CH2M HILL BOISE
ARCHIVED STORAGE

Envirosafe Services of Idaho, Inc.
Grand View, Idaho
ESII Site B
Site Characterization and Groundwater
Monitoring Program
February 1986
Volume IA-Text

INSTRUCTIONS TO REPORT HOLDERS

FIGURE E-2.2
TOPOGRAPHIC SETTING
OF ESII SITE B

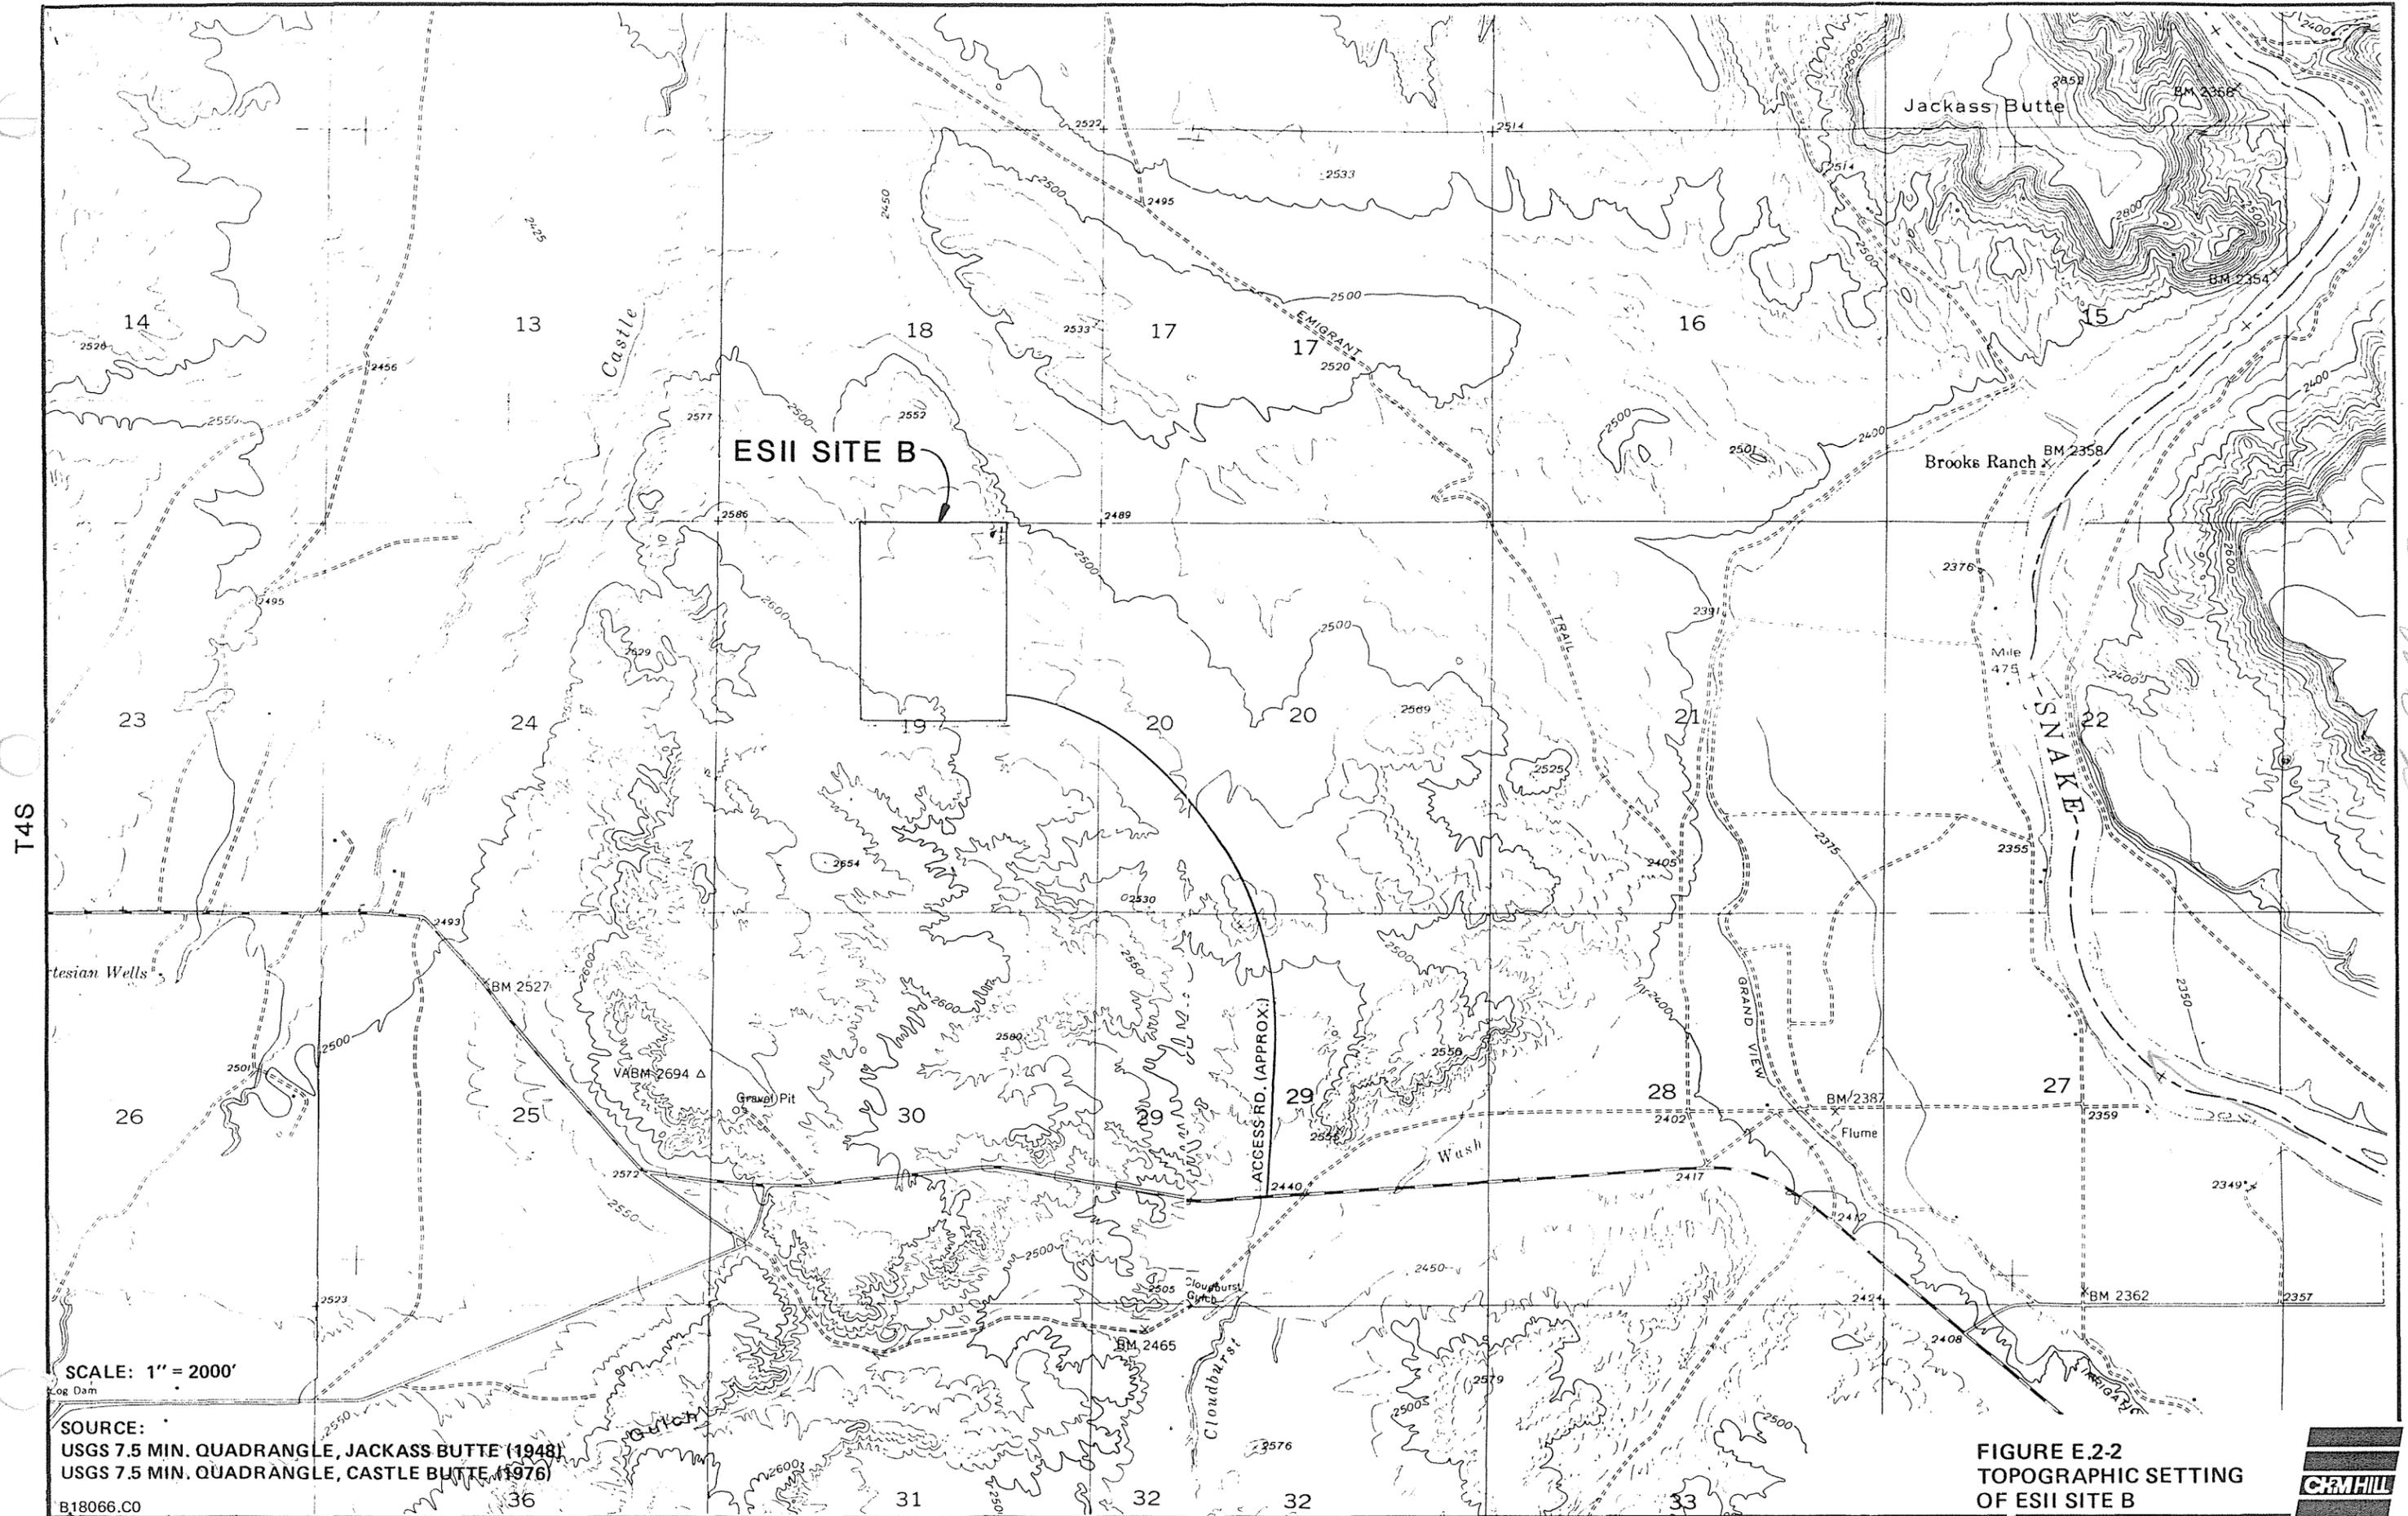
add average at site for period of record

add direction arrows

add ESI site data for period of record, (wind rose)

FIGURE E.3-1
 WELL AND BORING
 LOCATIONS

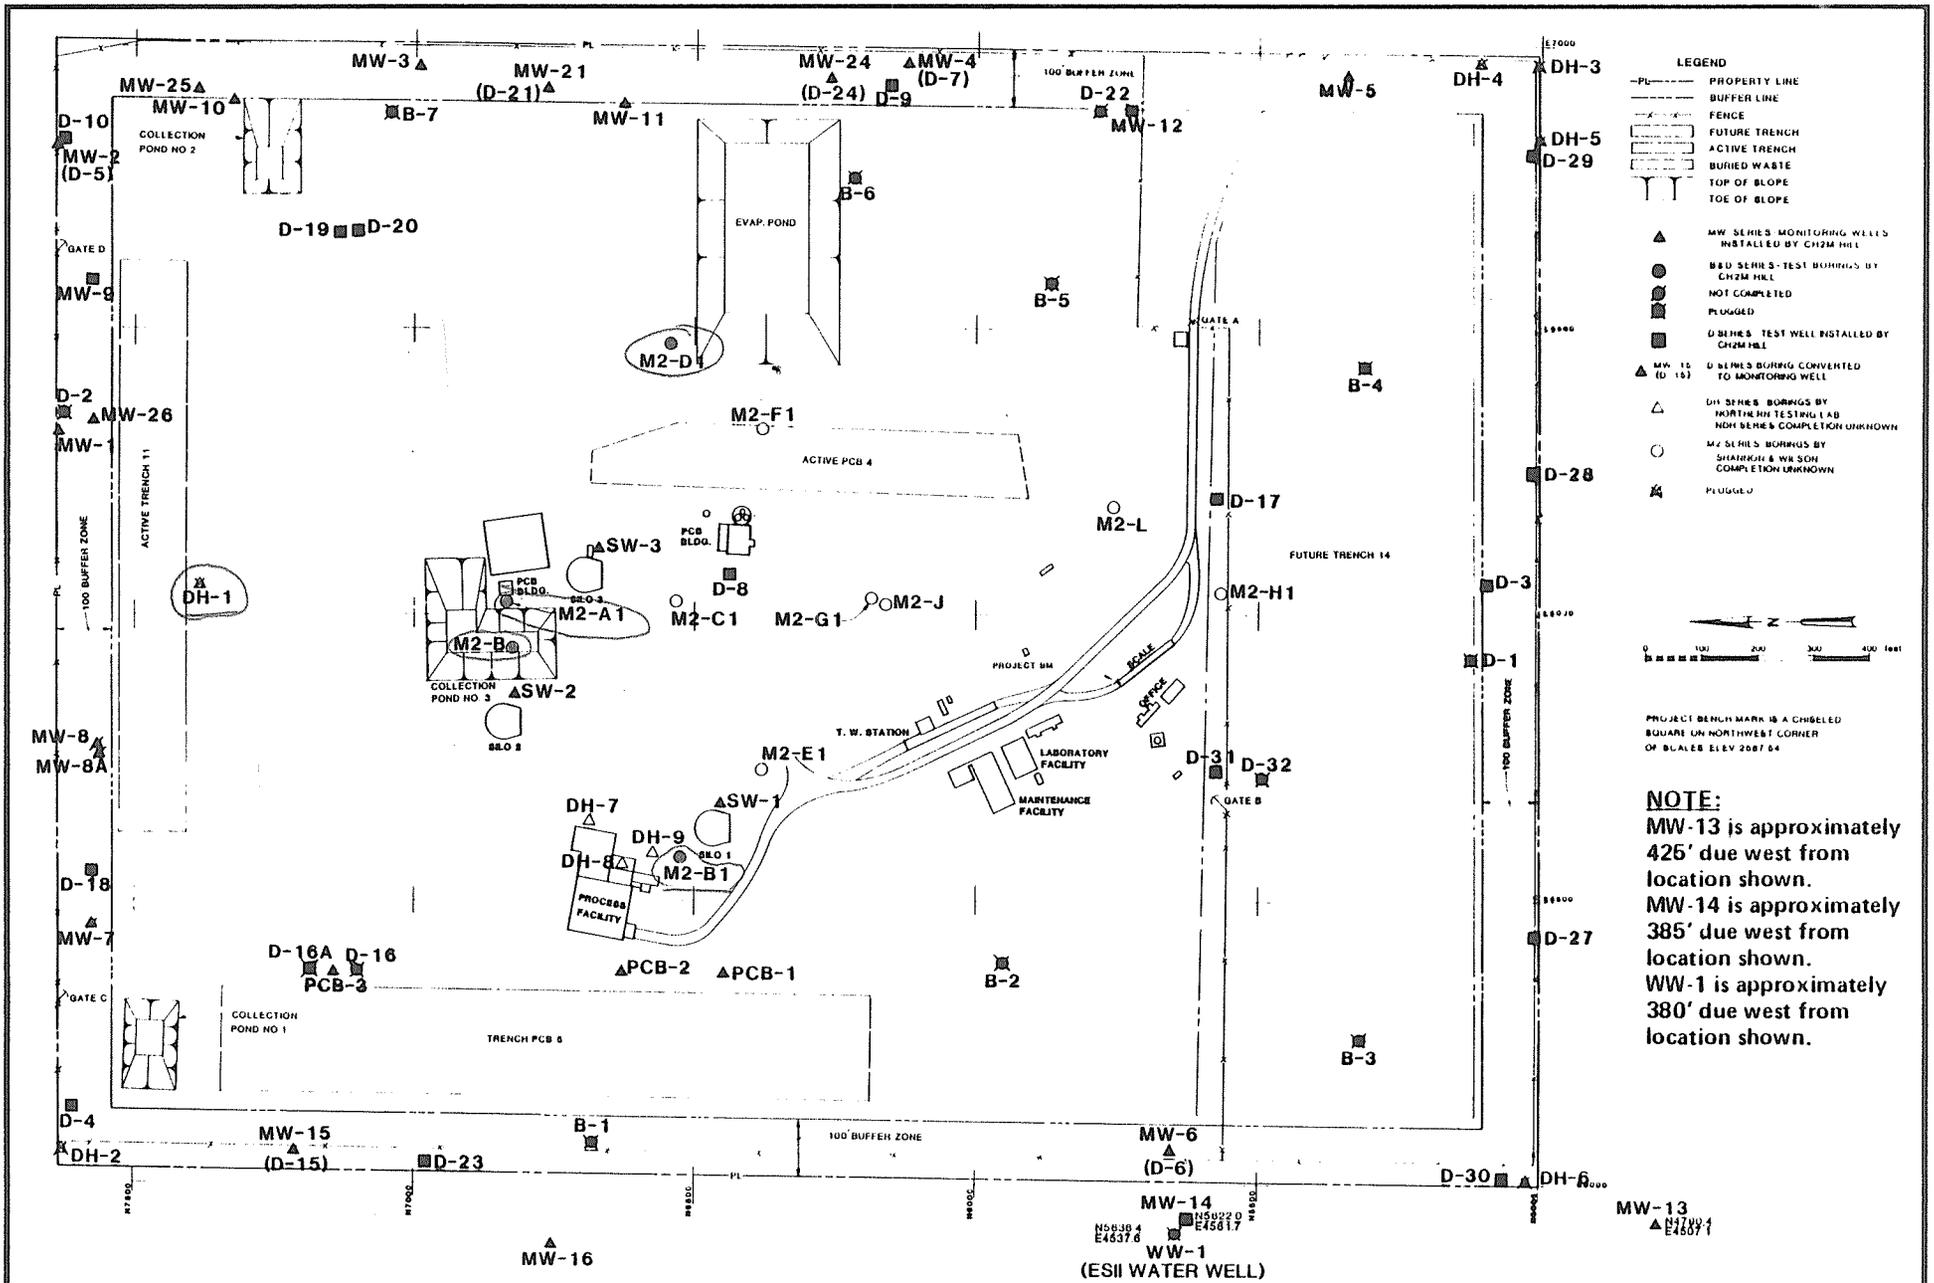
*all SW-1-2
SW-3-2*

add SW 3.2, 1.2, D-33, D 29
